### Addendum No. 1

Subject: Bid B-014C of 19/20 for General Contractor Services on Structural Repair

**Location:** Robert Morris Elementary School

| SK-1

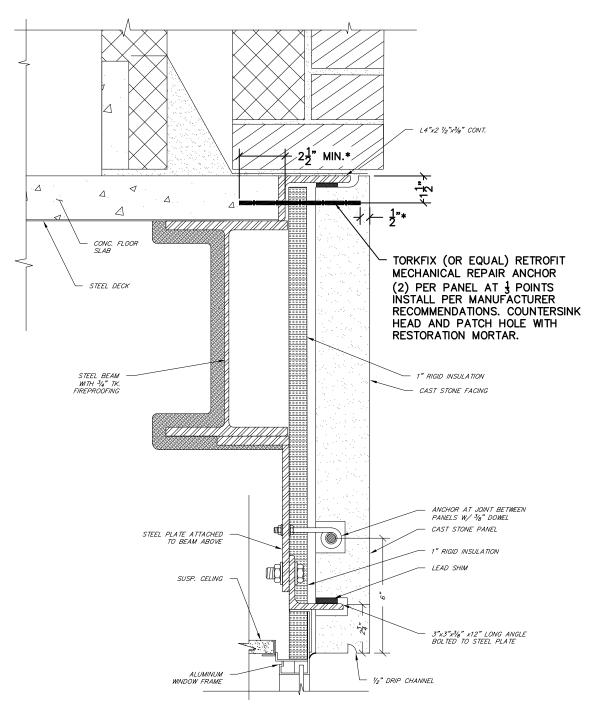
2. Detail 4 S-3, 11 S-3: is the intent to drill through embedded steel angles to install anchors, especially detail 4 S-3.? Helical ties notes on S-1 Item 6 states to avoid damaging existing reinforcing or embedded items

Detail 4/S-3: Cramp anchors shown in section are located at two points along the panel length. The intent of this detail is to avoid existing cramp anchor locations, while anchoring the cast stone panel at the bottom joint. See updated detail on SK-1 moving helical anchor location to cast stone panel face.

\*ANCHOR DEPTHS ARE NOMINAL. ACTUAL EMBEDMENT DEPTH SHALL CONFORM WITH ANCHOR MANUFACTURER'S RECOMMENDATIONS.
